NUMBER
231 (Rev 3, 11/30/2021)

TECHNICAL SERVICE BULLETIN

FRONT VIEW CAMERA REPLACEMENT FOR DTC C160449 & C160649

This bulletin has been revised to include additional information. New/revised sections of this bulletin are indicated by a black bar in the margin area.

Front View Camera

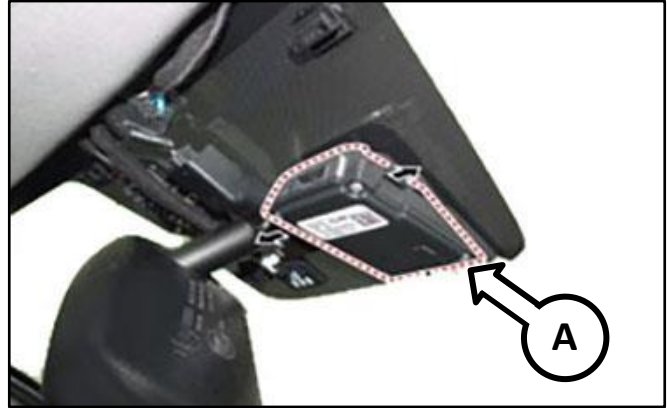
This bulletin provides information on the inspection and replacement of the front camera on some vehicles listed below. Due to an internal control chip concern inside the camera, the vehicle may exhibit a Forward Collision Avoidance Assist Warning Lamp (A) and/or Master Warning Lamp (B) with C160449 and/or C160649 codes. Certain systems may become temporarily disabled during occurrences: Smart Cruise Control (SCC), Lane Keep Assistance (LKA), Lane Departure Warning (LDW), Forward Collision-Avoidance Assist (FCA), Forward Collision Warning (FCW) and/or Driver Attention Warning (DAW). Follow the procedure outlined in this publication to diagnose and replace the front view camera assembly.

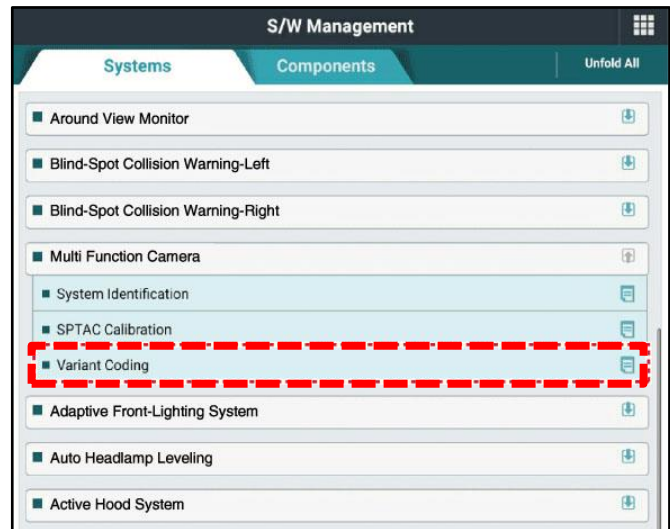
1. Remove and replace the Front View Camera (A) by referring to the “Body Electrical System → Front Camera System → Front View Camera Unit → Repair Procedures” chapter in the applicable Shop Manual on KGIS.

2. Perform the “Variant Coding” procedure by referring to the “Body Electrical System → Front Camera System → Repair Procedures” chapter in the applicable Shop Manual on KGIS.

After replacing the front camera with a new unit, the Variant Coding procedure must be performed.
